Reflections on FEC Ad-Hoc group resolutions

IEEE 802.16.abc-01/37

2001-09-12

Reflections on 'FEC Ad-Hoc Group' Resolutions

Results

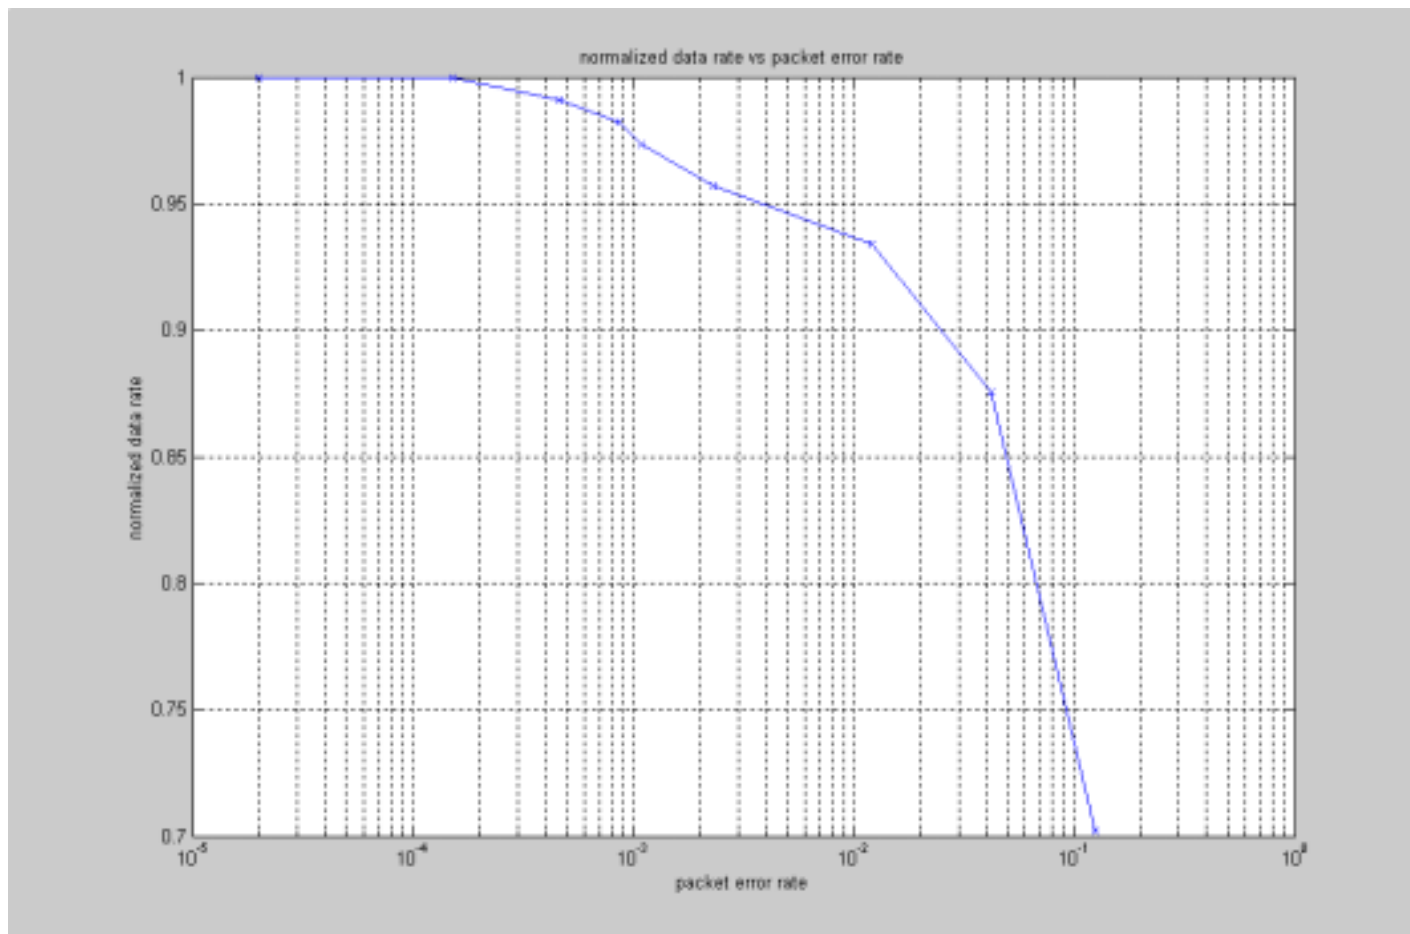
- Majority of contributors:
- CC is better at 10^{-5} error event /byte.
- RS+CC is better at lower error probabilities.
- Disagreement with Yossi on Multipath results.
(Not same conditions were simulated)
- Yossi showed the advantage of using soft output and erasures.
